Eng: David Hurdle		Paul, C. Buff Inc.	
PCB81878781		2725 Bransford Ave.	
<User Ext.#3>		Nashville, TN 37204	
<User Ext.#4>			
<User Ext.#5>			
Sheet File Name:		RadioRebate Receiver	
BFRX.sch		1028781	
Sheet Drawing date:		11/04/1999	
		SHEET 1	
		OF 1

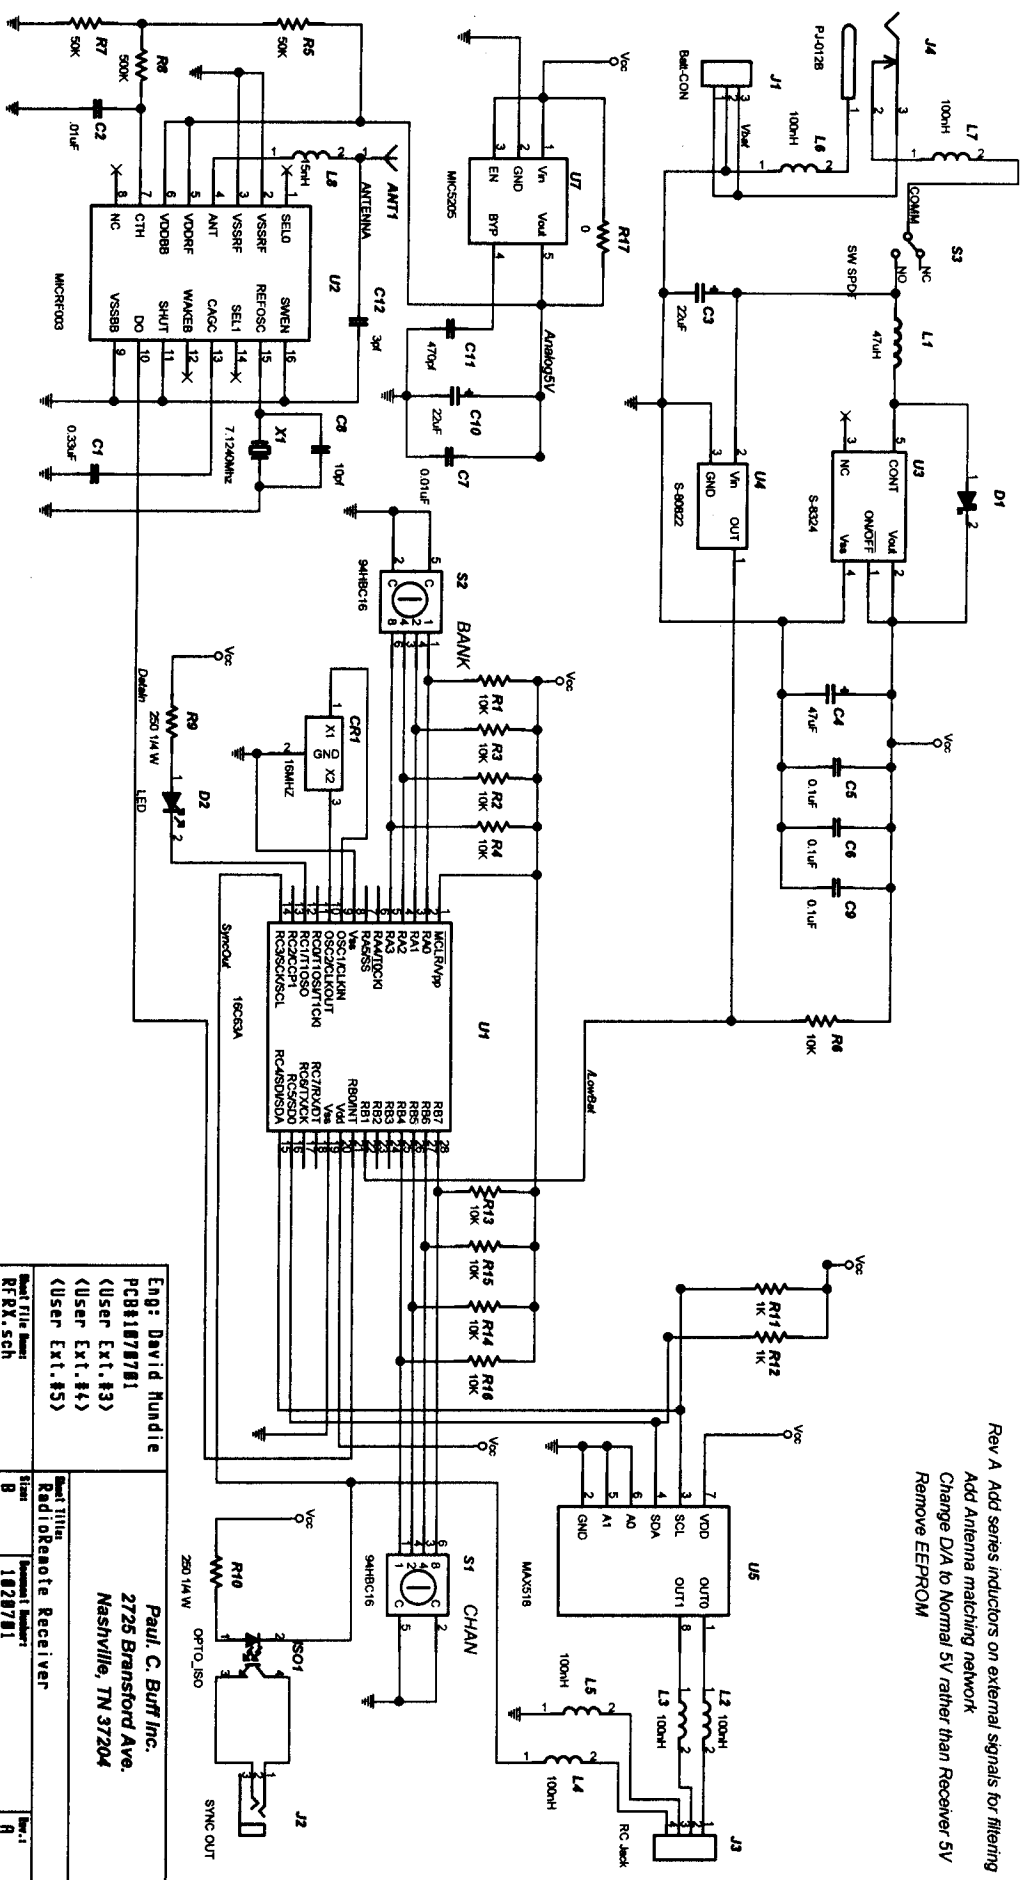
Rev A Add series inductors on external signals for filtering
 Add Antenna matching network
 Change D/A to Normal 5V rather than Receiver 5V
 Remove EEPROM
